PATENT  
Reply under 37 CFR 1.116  
EXPEDITED PROCEDURE  
Group 1731

AMENDMENT(S) TO THE DRAWINGS

## Annotated Marked-UP Drawings

FIG. 9

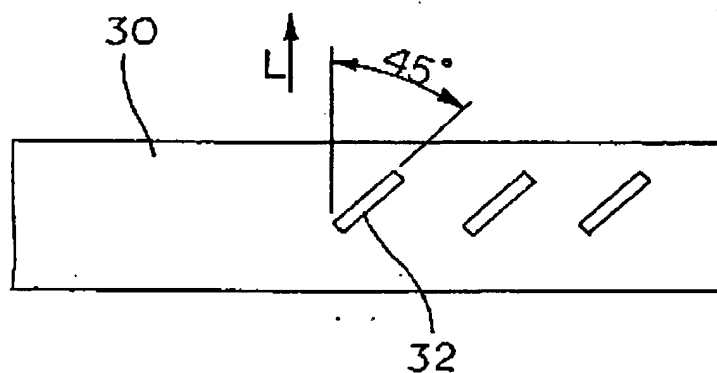
*Deleted 2B  
from Fig. 9*

FIG.10

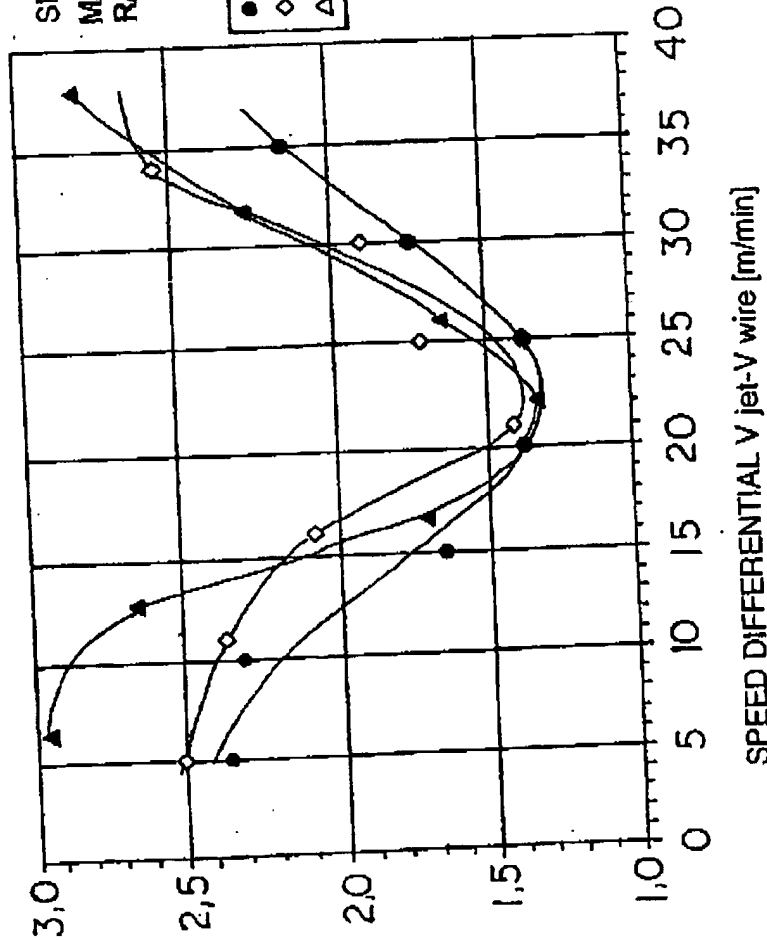
*Changed F6M and  
Raw Material Lines*

FIG.11

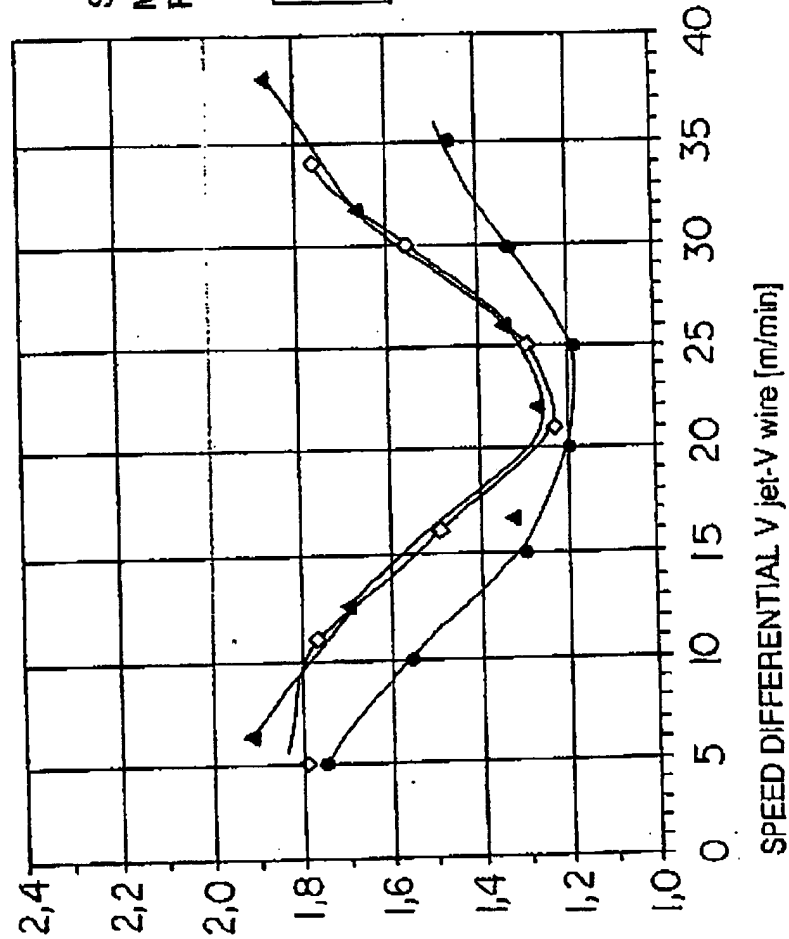
*Changed F6M and  
raw material lines*

FIG.12

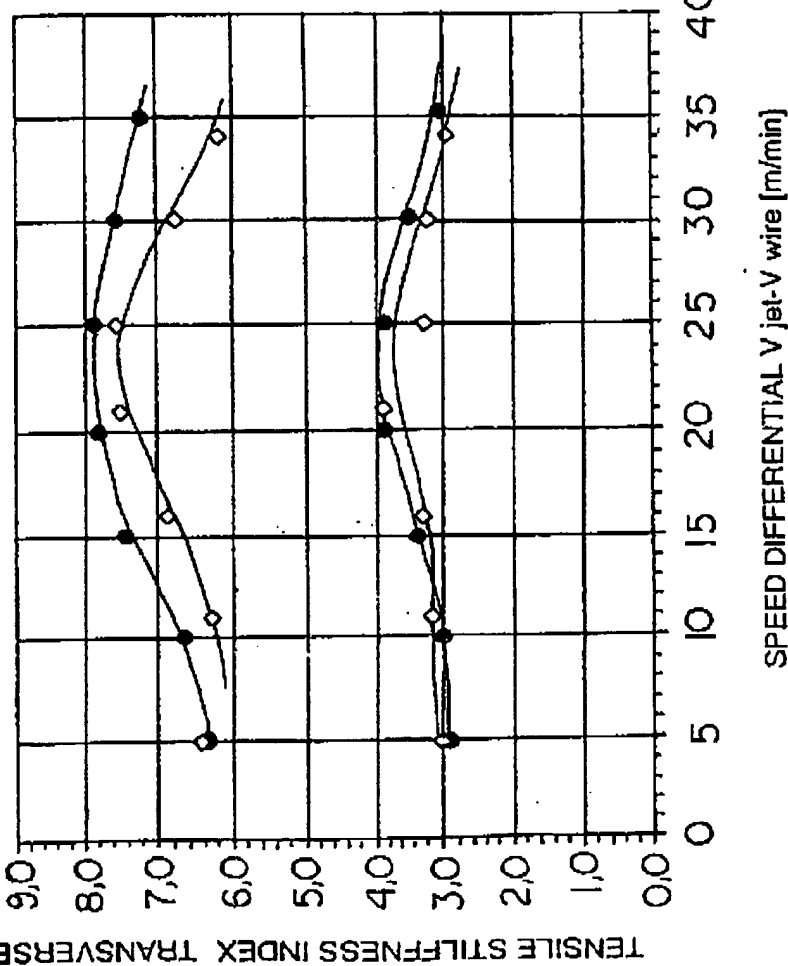
*Changed F6M and  
raw material lines*

FIG.13

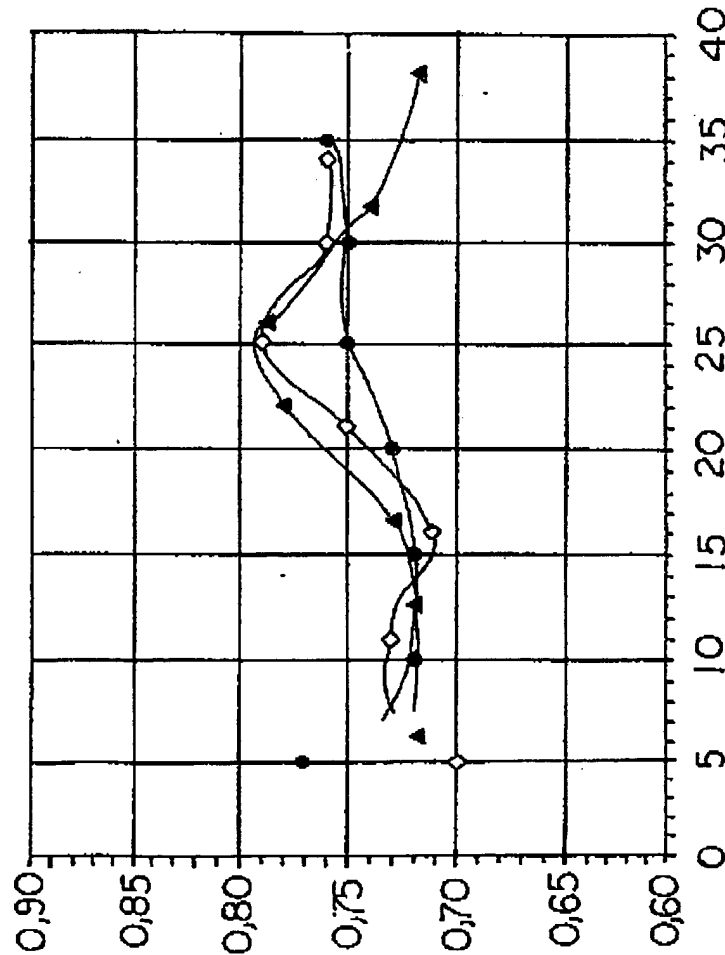
*Changed Fbm and raw material lines*

FIG.14

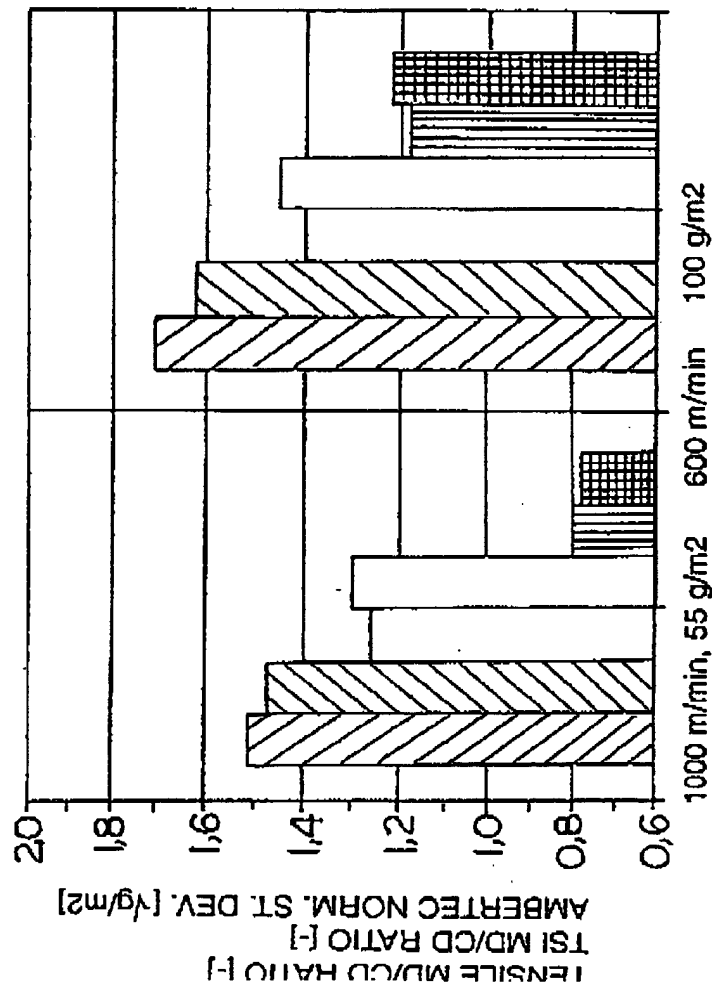
*Changed FBW  
and raw material  
lines*

FIG.15

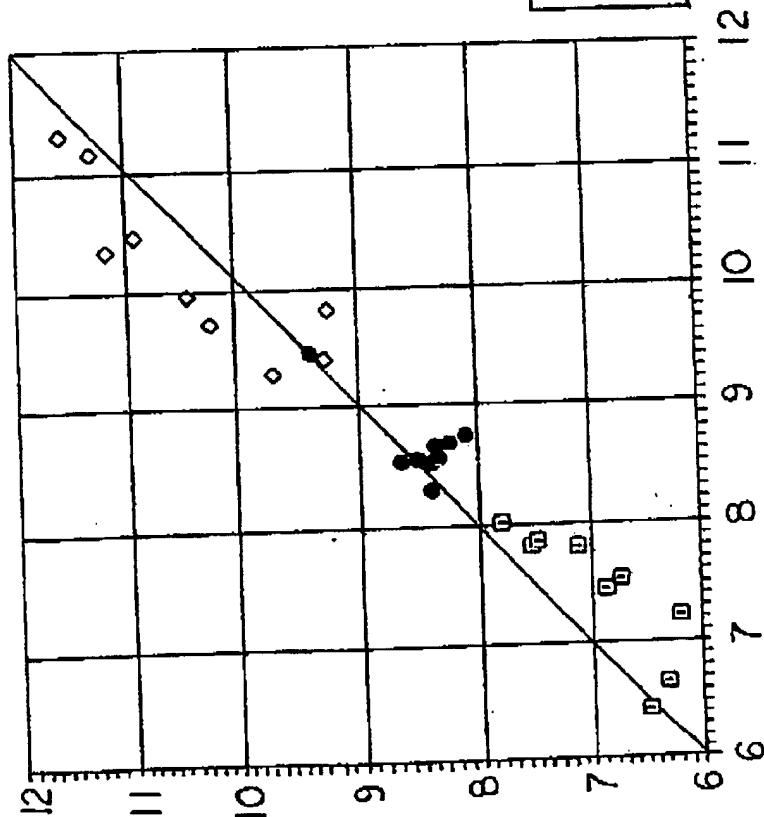
Change Flm and  
raw material lines

FIG. 16

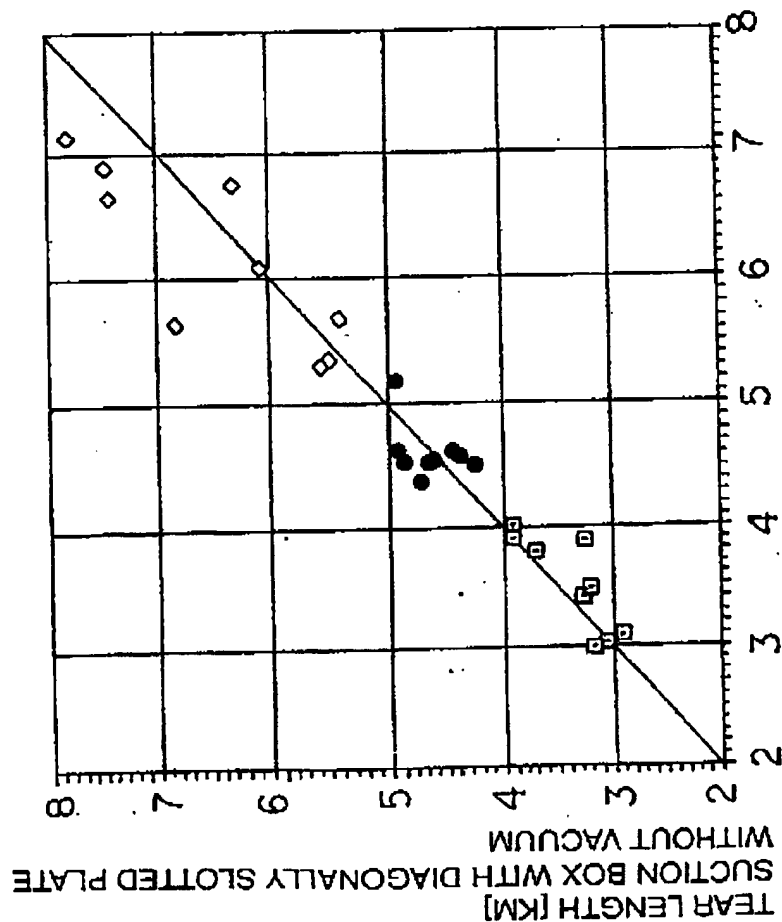
Changed Fiber and  
raw material lines
